GIOR-MILTON PLAZA SUBDIVISION

APPLICATION NUMBER 7 DATE October 1, 2015

APPLICANT Gior-Milton Plaza Subdivison

REQUEST Subdivison

DETAIL SITE PLAN

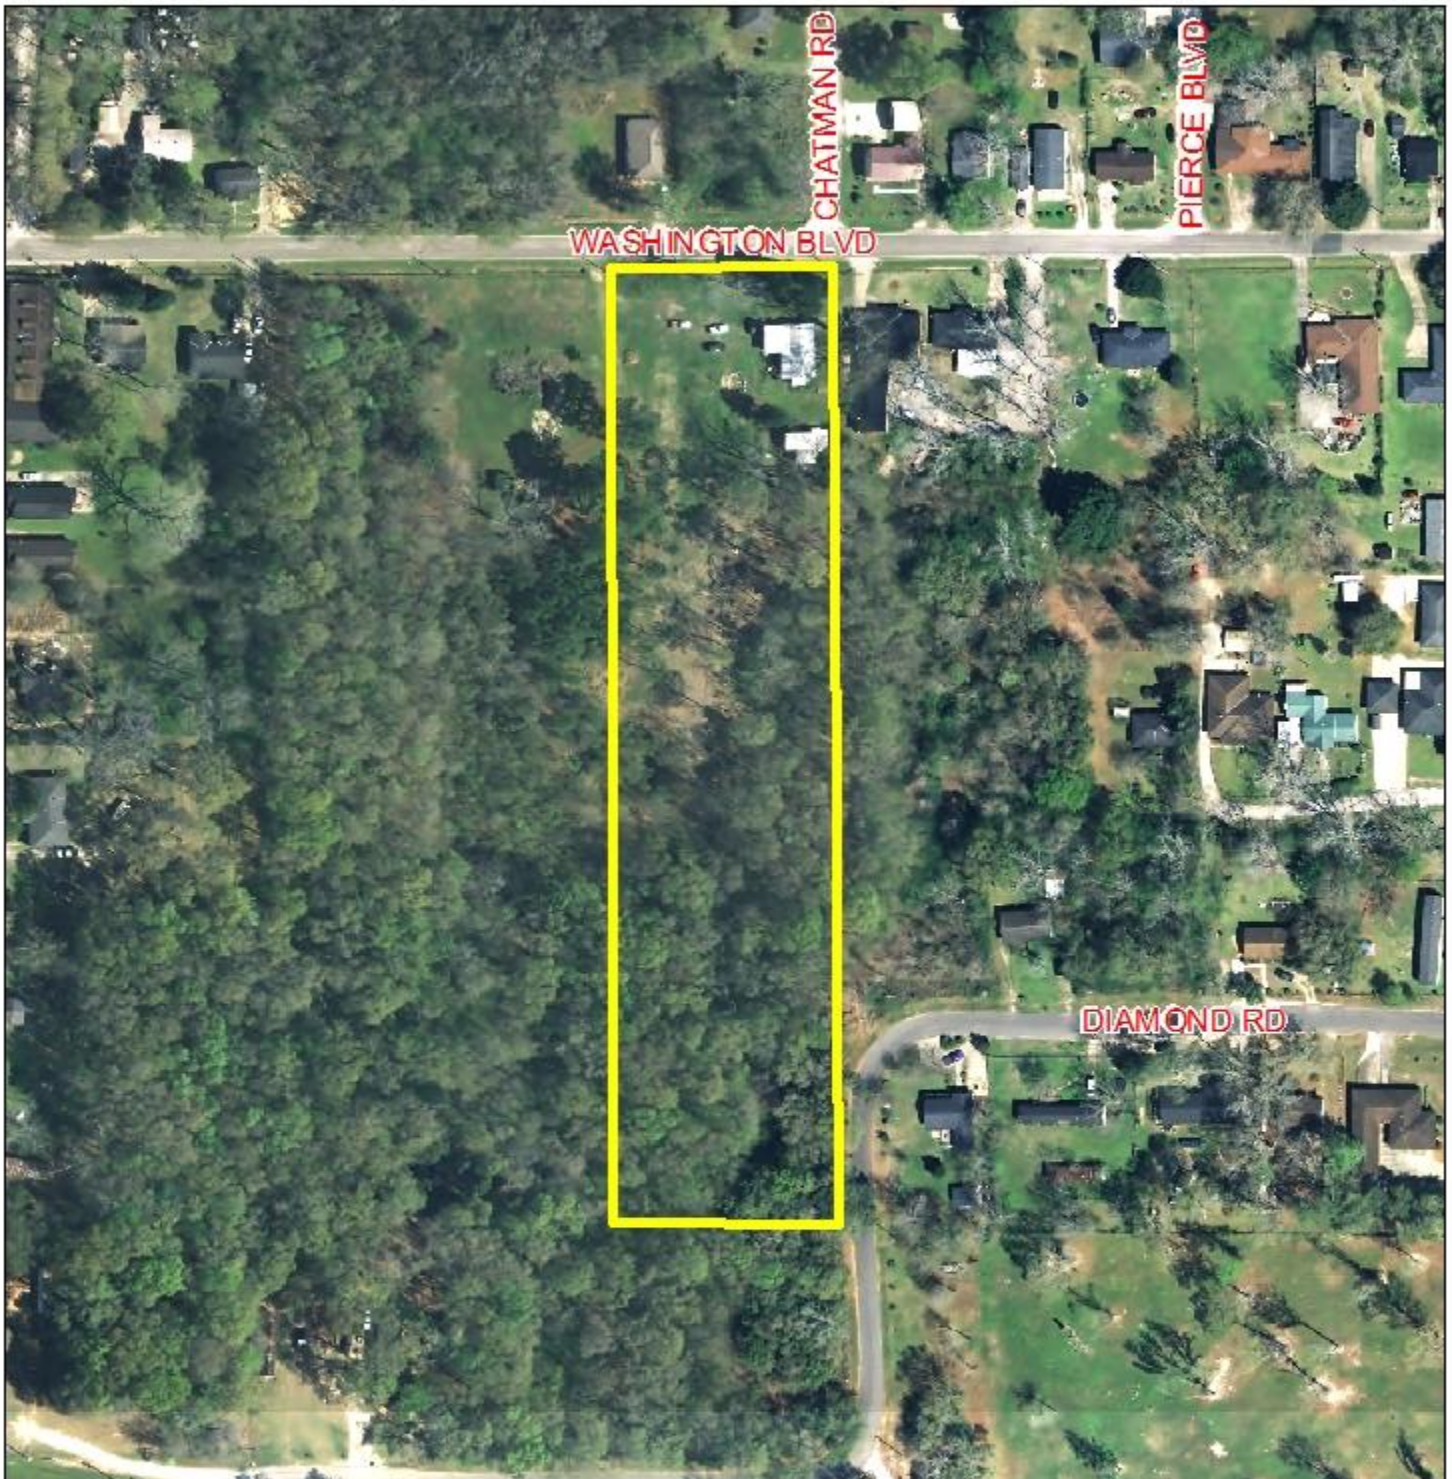
The site fronts Washington Boulevard, a minor street without curb or gutter. The preliminary plat depicts Washington Boulevard as having a 50' right-of-way. A minimum 60' right-of-way is required for streets without curb and gutter, thus dedication to provide 30' as measured from centerline of Washington Boulevard will be required. Lot 2 additionally has frontage onto Diamond Road, a minor street with adequate right-of-way.

The proposed lots appear to meet the minimum size and frontage requirements as regulated by Section V.D.2. of the Subdivision Regulations. However, the lots do not comply with Section V.D.3. of the Subdivision Regulations regarding the maximum width to depth ratio. Lot 2 also has frontage onto Diamond Road making it a double frontage lot which does not comply with Section V.D.8 of the Subdivision Regulations. Thus, a waiver of Section V.D.3 and V.D.8 will be required in order to approve the subdivision as proposed.

Lot 2 is developed with a residence and with one existing curb-cut to Washington Boulevard. If approved, a note should be placed on the Final Plat stating each lot is limited to 1 curb-cut with the size, design, and exact location to be approved by Traffic Engineering, and conform to AASHTO standards. Lot 2 should be denied access to Diamond Road.

The 25' minimum building setback lines are depicted on the plat. However, revisions along Washington Boulevard due to dedication should be made and the illustration of new 25' minimum building setback lines should be depicted on the Final Plat. The plat should also be revised to depict a 25' minimum building setback line along Lot 2 where the lot has frontage along Diamond Road.

The lot sizes in square feet and acres are labeled on the preliminary plat; however, the lot sizes in square feet and acres should be adjusted on the Final Plat to reflect dedication, or there should be the provision of a table on the plat depicting the revised information.

- 1) dedication sufficient to provide 30' from centerline of Washington Boulevard;
- 2) revision of the 25-foot minimum building setback line to reflect dedication and depiction along Diamond Road;
- 3) revision of the lot sizes in square feet and acres to reflect dedication;
- 4) placement of a note on the Final Plat stating that each lot is limited to 1 curb-cut to Washington Boulevard, with the size, design, and exact location to be approved by Traffic Engineering, and conform to AASHTO standards;
- 5) placement of a note on the Final Plat stating Lot 2 is denied access to Diamond Road;
